## **MEMORANDUM**

### **HISTORIC PRESERVATION COMMISSION Tuesday, August 21, 2018, 8:00 a.m. City Commission Room AGENDA**

## CITY OF FARGO – Historic Preservation Staff Report

**DATE:** August 10, 2018  
**TO:** Historic Preservation Commission  
**FROM:** Kylie Bagley, Assistant Planner  
**RE:** Storefront/Downtown Rehab Grant Program – 402 Broadway North

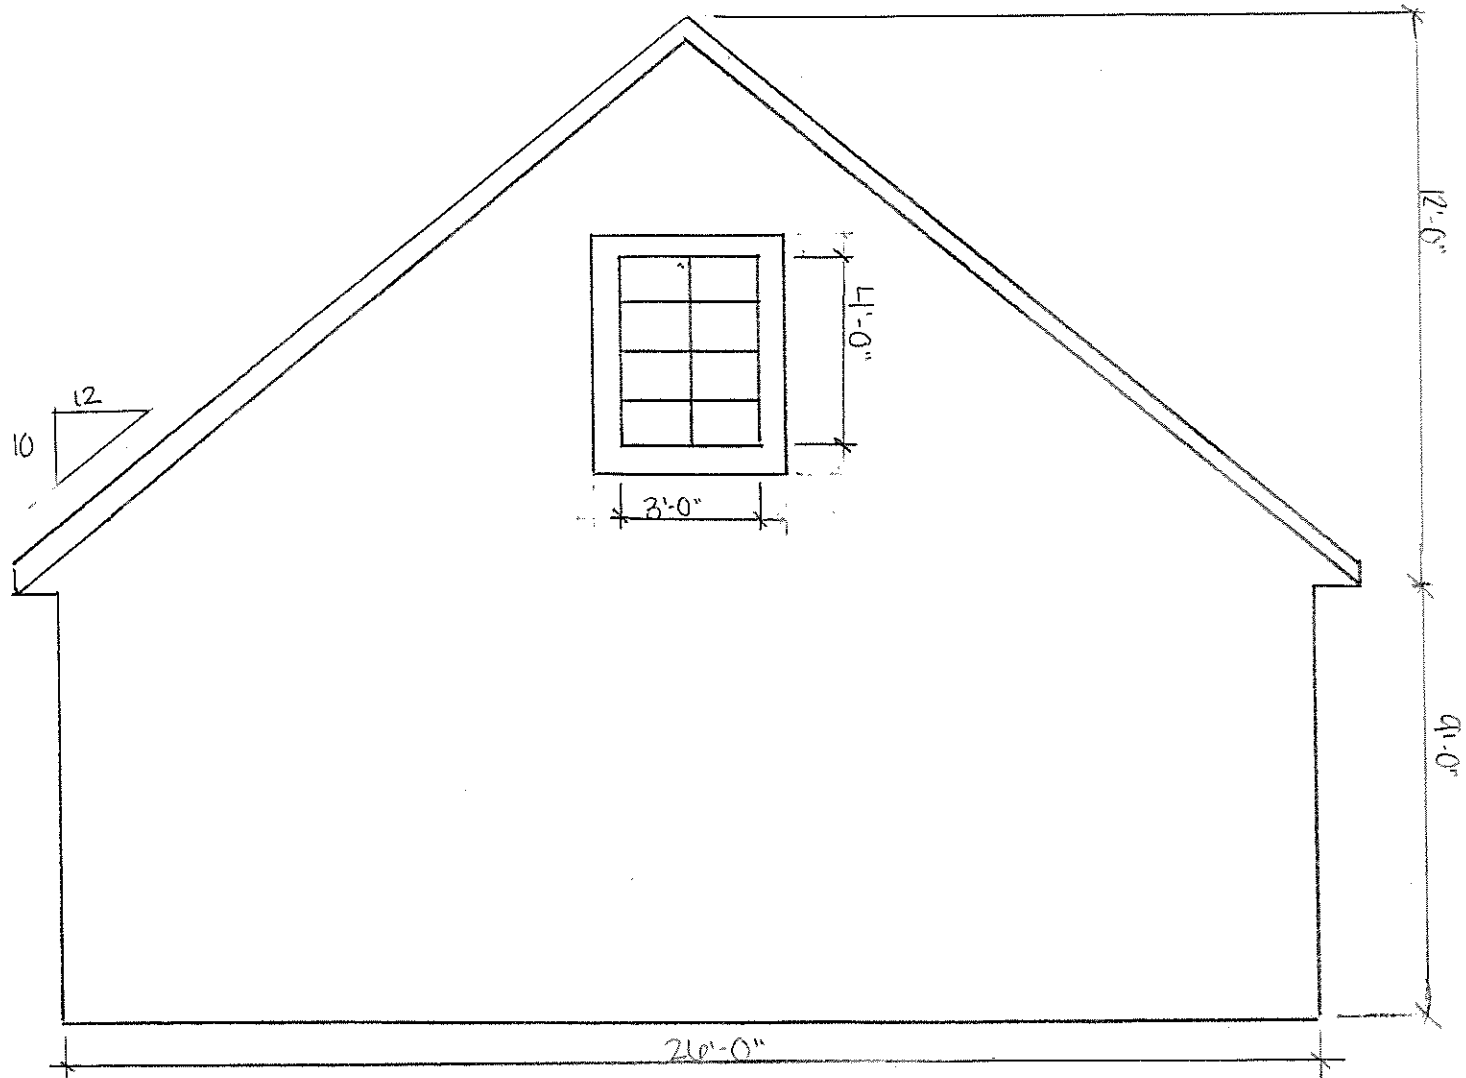
The applicant is proposing to build a new garage and construct a new driveway. The garage will be 26' x 28' x 21'. The garage will face 10<sup>th</sup> Avenue South, the applicant is proposing to have two garage doors which will be 9 feet in width and 8 feet in height.

The new garage will be facing the street but the garage doors will not exceed 10 feet in width or 8 feet in height.

**Staff Recommendation:** “Recommend approval of a Certificate of Appropriateness for the proposed garage as presented based on the review criteria of Ordinance Number 4910; the proposal will still need to meet all applicable criteria and codes of the City of Fargo.”

402 BROADWAY STOREFRONT  
A7: Proposed Building Elevation

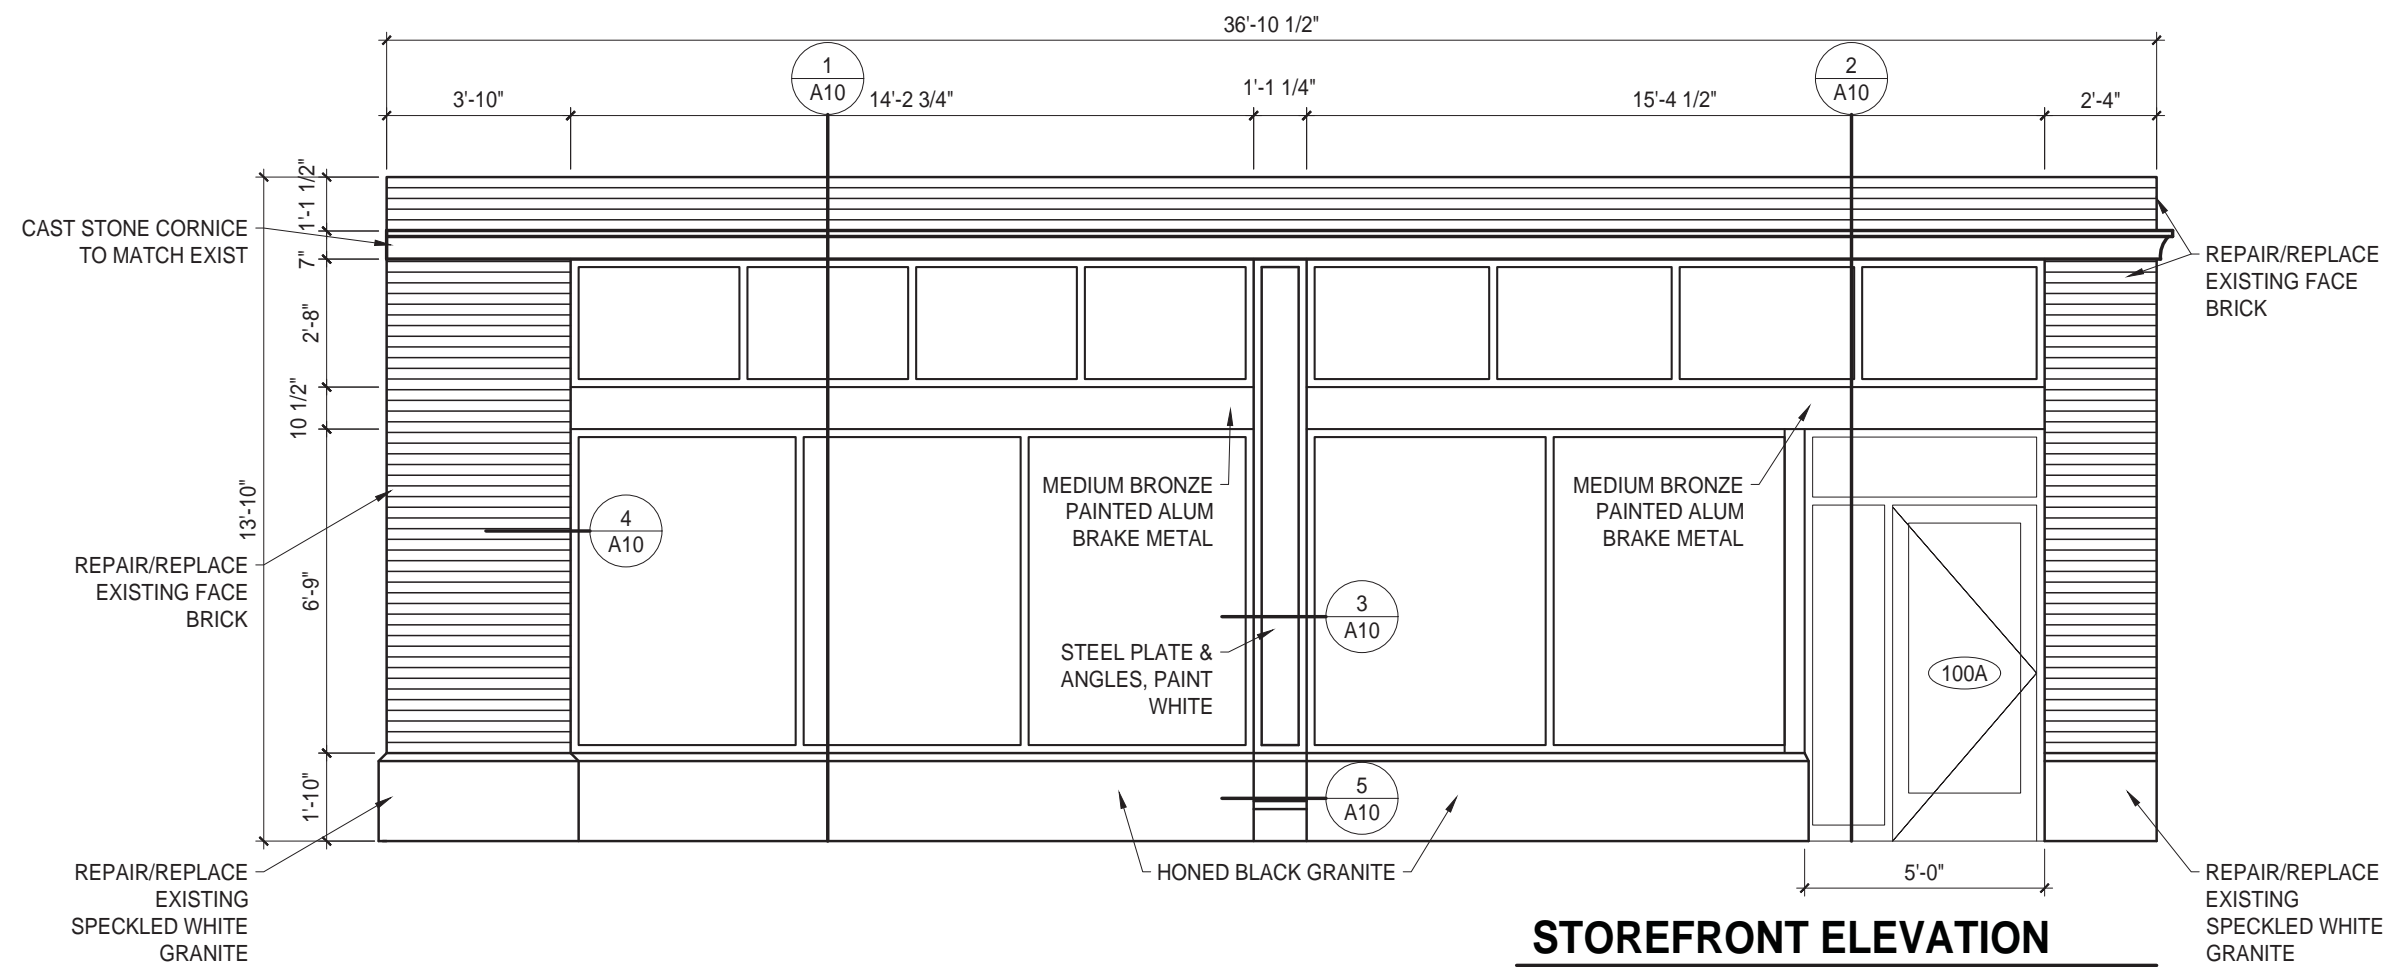
- The storefront will be constructed of painted aluminum framing, with a center-glazed 2" x 4-1/2" profile, taking cues from the narrow framing profiles of the historic storefront. High performance glazing, Solarban 70XL, will be utilized for its balance of energy performance and transparency. The narrow double door at the front will be replaced with a new single door to meet ADA clearance requirements. A dark granite base is being incorporated at the sidewalk level for durability and is in proportion to original raised base of the storefront, though without window openings to the basement.

- The aluminum framing and panning will be a painted finish to match the medium bronze of the window framing at the 400 storefront. The center pilaster, presumed to be a poured concrete column, will be clad with a steel skin, mimicking the cast iron pilasters flanking the 400 storefront entry.

possible or replacement with matching materials will be required. The cornice directly above the 402 storefront, removed in the 1938 remodel, will be replaced with a custom cast stone piece matching the color and profile of the original cornice.

Staff recommends a finding of "No Historic Properties Affected"

**01 SOUTH ELEVATION - PROPOSED**  
Scale: 1/16" = 1'-0"

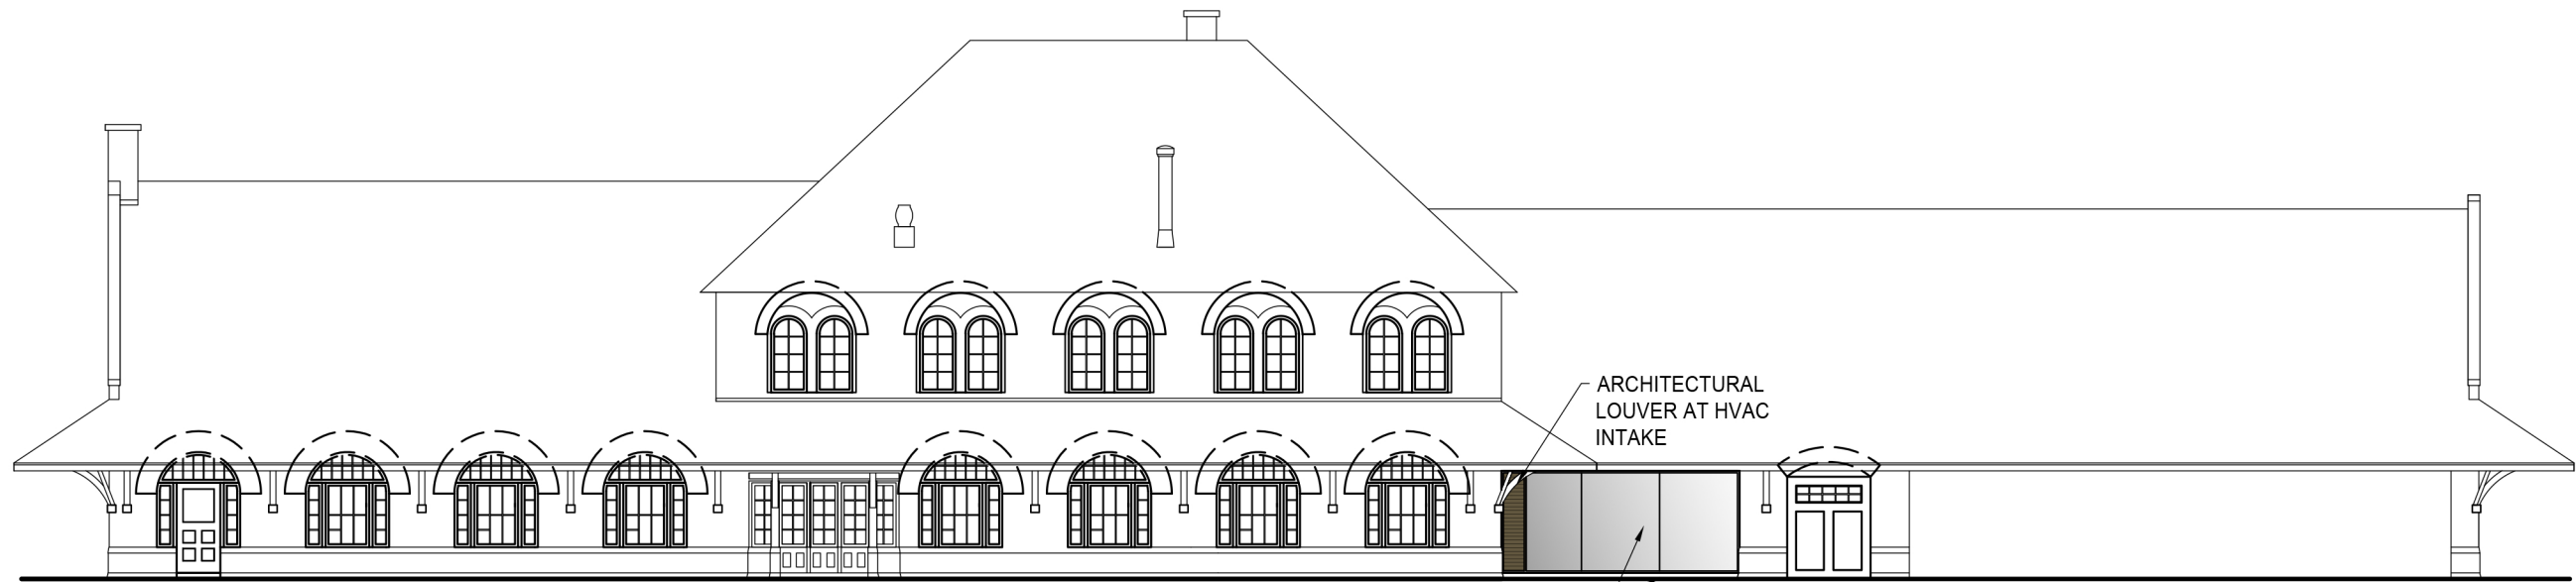
The proposed project involves an infill project of the 'baggage breezeway' between the two first floor sections of the building. The project will allow for contiguous space for Park District operations, and provides an increase in available floor area.

The roofline and second floor of the building continues over the breezeway. The proposed infill walls are held back from the face of the masonry and the timber-frame trusses on each side. The infill wall are constructed of black-painted aluminum curtainwall. The bottom portion of the walls will be butt-glazed to minimize exposed metal. Glazing with the gray-tinted glass is proposed. Above the glazing, which is also above the eave line and behind the timber-frame trusses, the curtainwall will be infilled with black-painted louvers, to allow for existing ventilation that terminates in the breezeway to be directed to the exterior. The interior of newly enclosed space will retain the exposed brick and stone, heavy-timber brackets and the bead-board ceiling.
